EXTERIOR WALL CONDITION ASSESSMENT REPORT

May 12, 2024

Regarding: Exterior Wall Condition Assessment

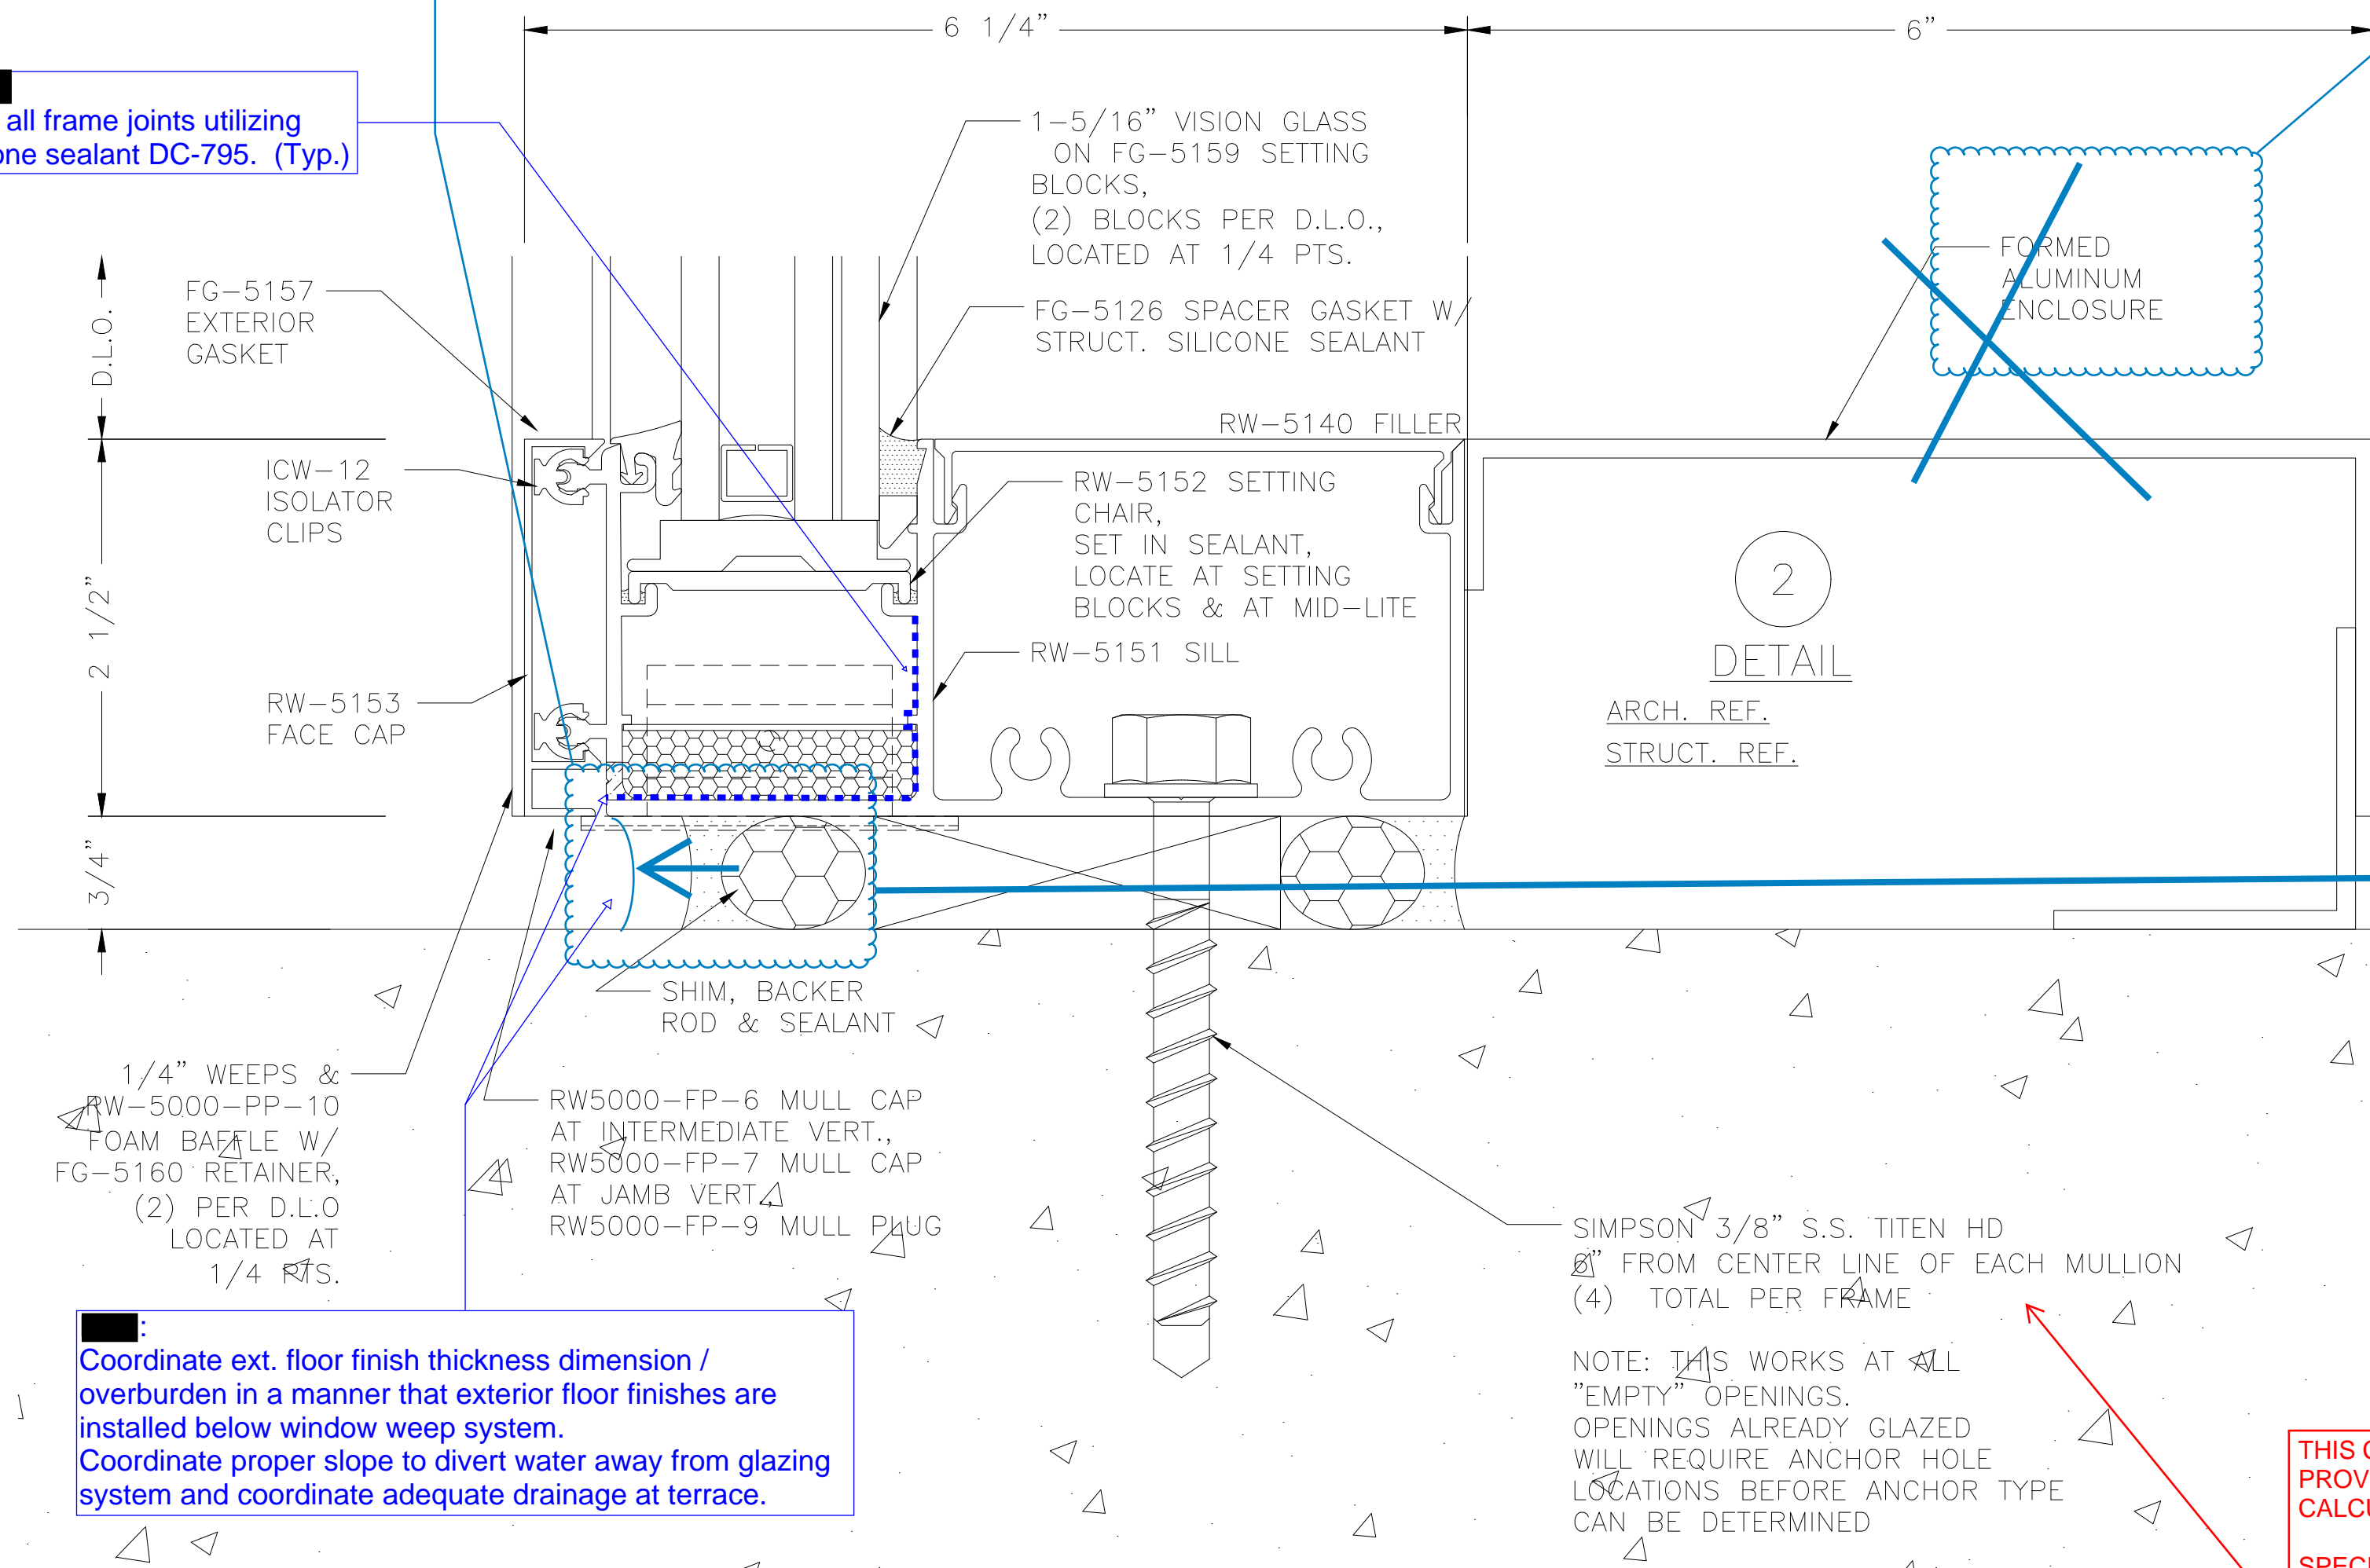
comment:
Architect / GC to coordinate indicate exterior sheathing and air/water membrane continuity at framed wall above glazing systems. (Typ.)
Recommend indicate in shop drawings for coordination.

██████ to confirm if location of sealant as noted does not work with their system, typ.

Seal all frame joints utilizing silicone sealant DC-795. (Typ.)

Coordinate ext. floor finish thickness dimension /
overburden in a manner that exterior floor finishes are
installed below window weep system.
Coordinate proper slope to divert water away from glazing
system and coordinate adequate drainage at terrace.

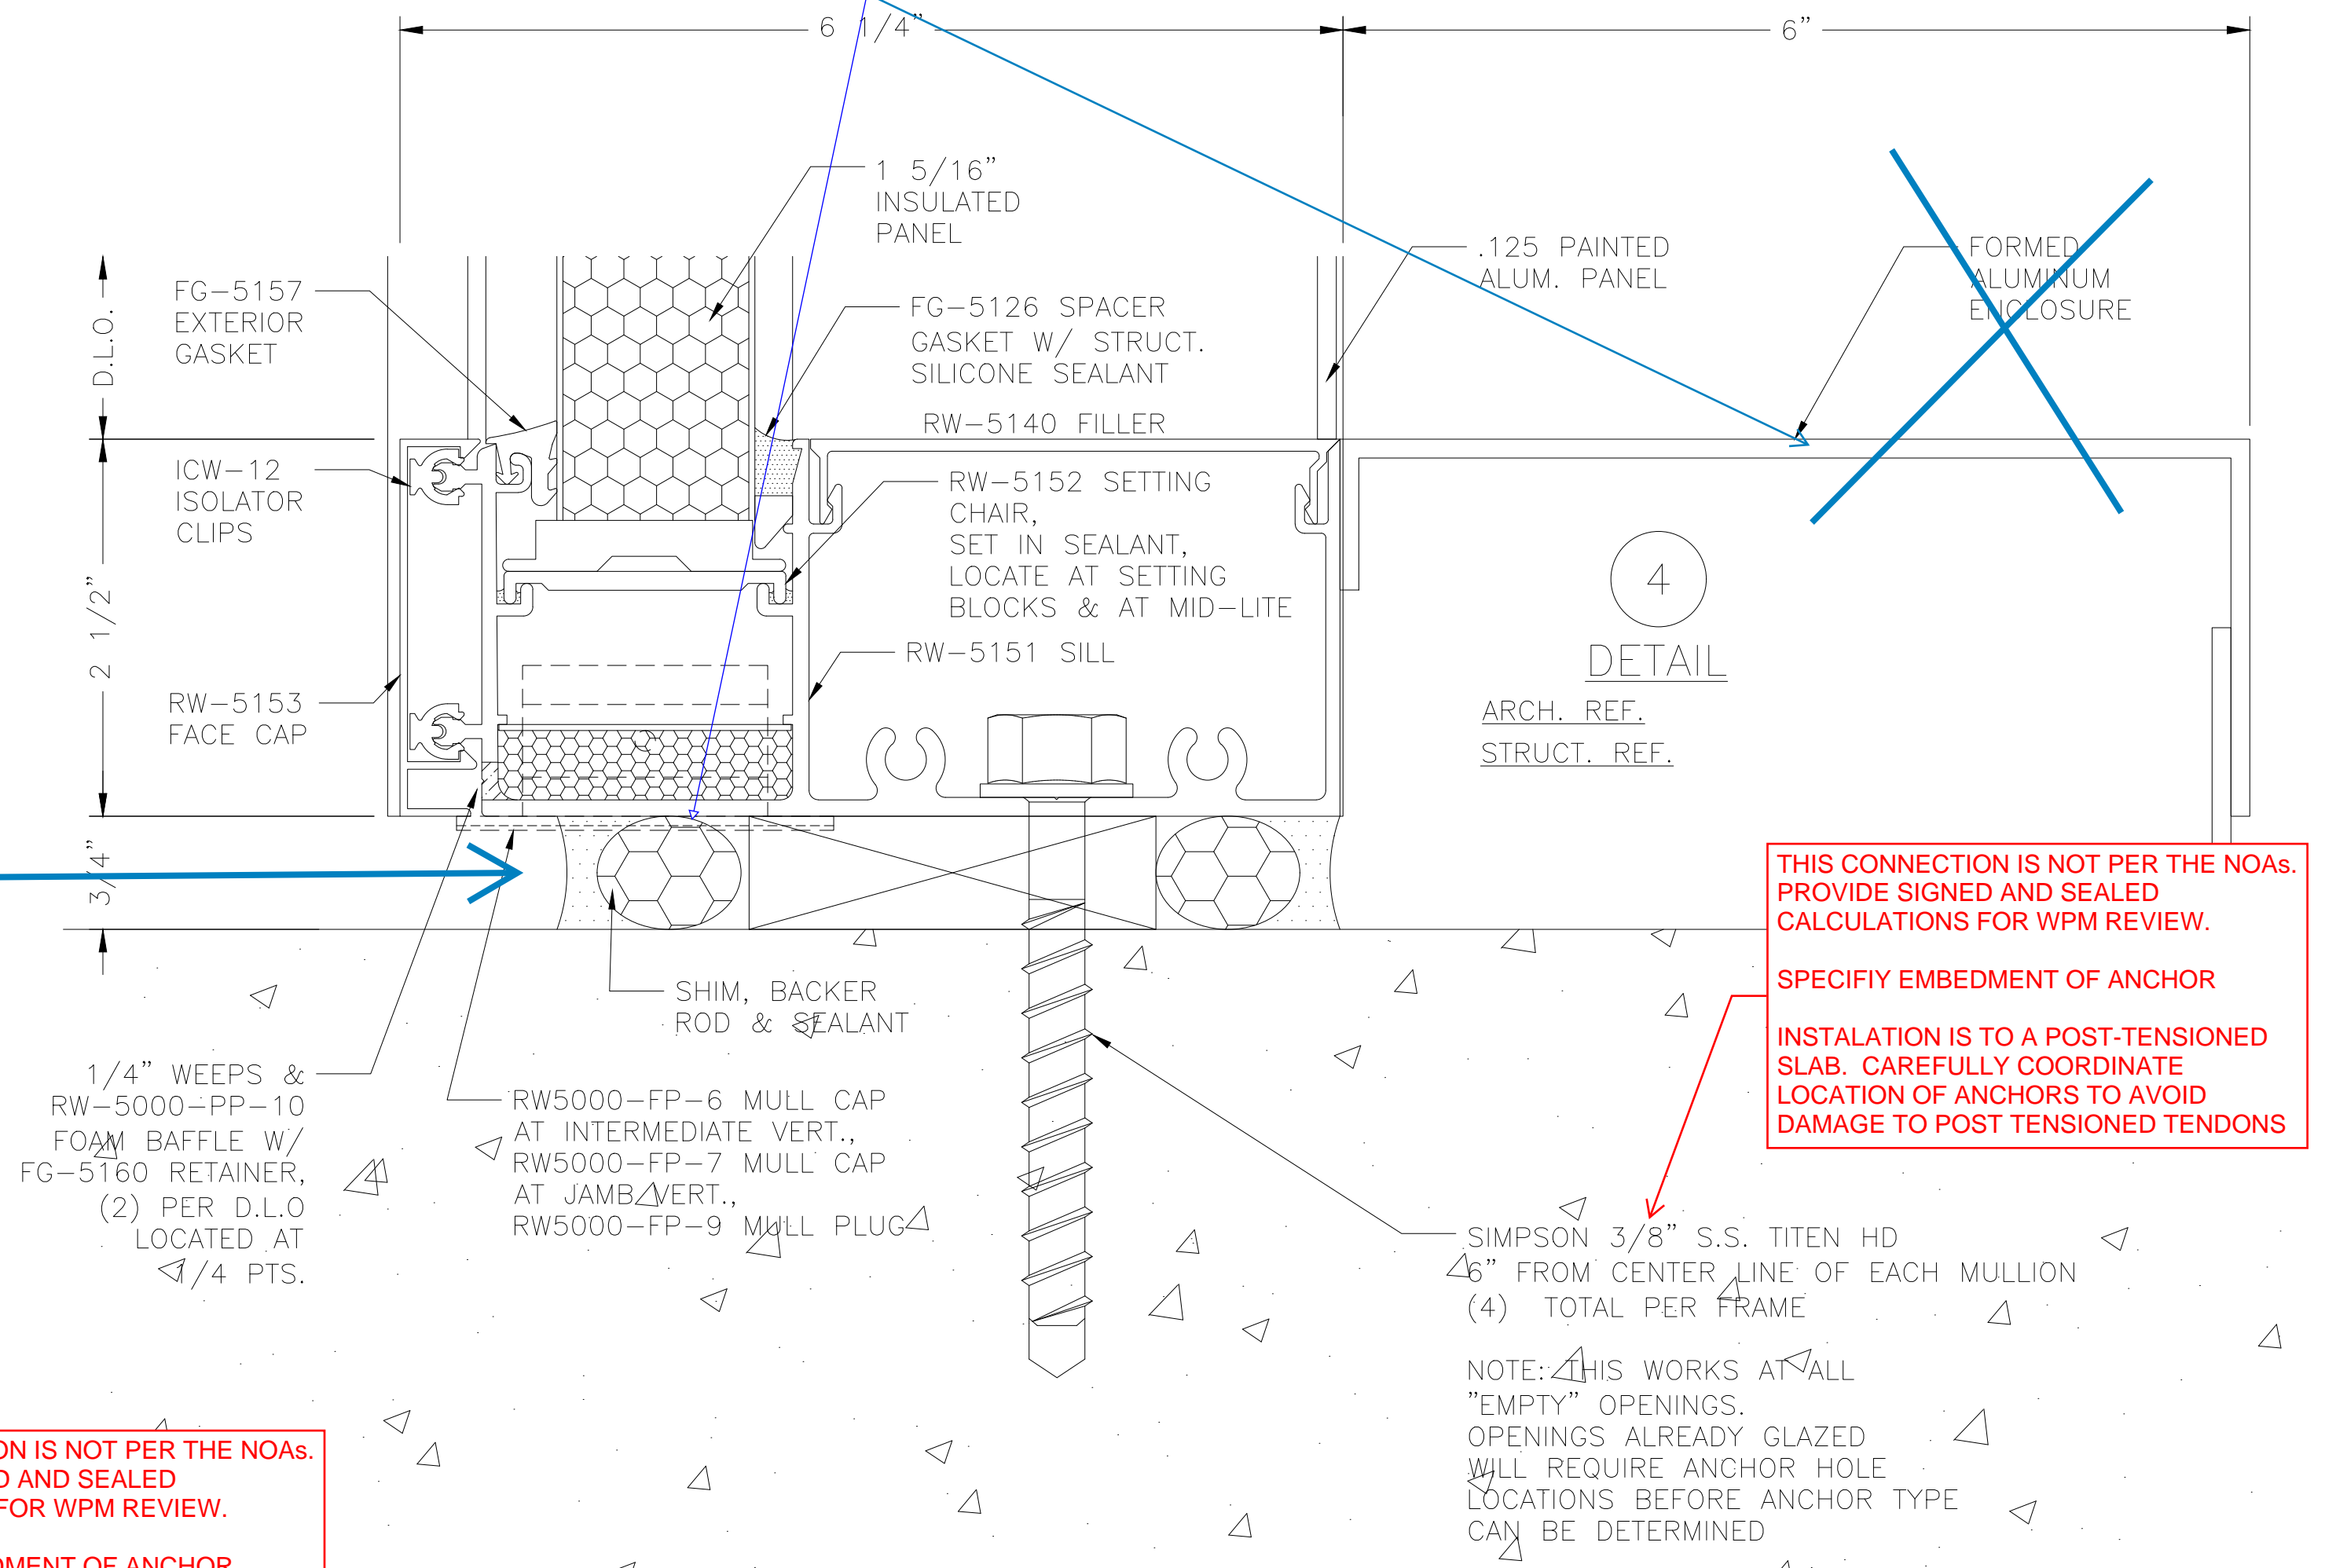
THIS CONNECTION IS NOT PER THE NOAs.
PROVIDE SIGNED AND SEALED
CALCULATIONS FOR WPM REVIEW.

SPECIFY EMBEDMENT OF ANCHOR

END CAPS:
Refer to [REDACTED] comments at detail 2 at sheet WW-301.
Refer to INSTALLATION NOTES at shop drawing sheet WW-500.

THIS CONNECTION IS NOT PER THE NOAs.
PROVIDE SIGNED AND SEALED
CALCULATIONS FOR WPM REVIEW.
